Smurfy Acres 2022 Replat; KPB File 2022-080 Geovera, LLC / Glanville Diamond Ridge Area / Kachemak Bay APC

#### **ITEM 11 - SMURFY ACRES 2022 REPLAT**

KPB File No.	2022-080
Plat Committee Meeting:	July 18, 2022
Applicant / Owner:	John and Laurie Glanville of Homer, AK
Surveyor:	Stephen Smith / Geovera LLC
General Location:	Sterling Highway, Diamond Ridge Road, Diamond Ridge / Kachemak APC

SMURFY ACRES 2022 REPLAT A REPLAT OF LOT 1 SMURFY ACRES (HM 85-30)

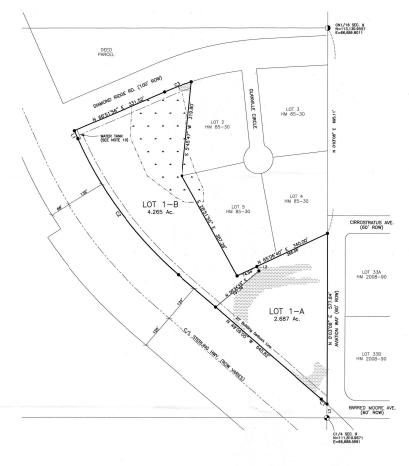
<u>Site Investigation:</u> There are some low wet areas present and are depicted on the plat. *Staff recommends* the wetland depiction remain on the final and a wetland determination plat note be added.

Some slopes exceed the 20 percent slope and are depicted with a hatching. **Staff recommends** the hatching remain on the final plat if it does not interfere with other required information.

The dedication of Aviation Way occurred after the creation of the parent lot within this preliminary plat. A setback along Aviation Way has not been created. **Staff recommends** the 20 foot building setback be put into place, if any existing permanent structures are in place they will require depiction and plat notes stating their exempt status must be added.

Per plat note 5, this plat will be granting utility easements within 10 feet of all rights-of-way. **Staff recommends** the plat note be reworded to closer match current code and to state that the easements are being granted by this plat and that the easements be depicted if possible.

**Staff recommendation:** Provide a width label for Glanville Circle. Provide a label for Lot 32 HM 81-08, located to the northeast. The deed parcel to the north has a preliminary design approved. A final has been submitted but not recorded at time of review. Prior to printing the mylar, verify the status of the lot to the north and update depiction and status labels as needed. Show separate lot distances along the line on Sterling Highway.

Staff recommendation: A setback should be put into place along Aviation Way.

- Per the Certificate to Plat, the property is subject to reservation of easement for highway purposes. Provide a plat note that states the different PLOs and the dates.

- Any person developing the property is responsible for obtaining all required local, state, and federal permits, including a U.S. Army Corps of Engineers wetland determination if applicable.

- Any required notes for improvements within new setbacks or utility easements.

Update plat note 5, "The front 10 feet adjoining all rights-of-way is granted by this plat as a utility easement. No permanent...."
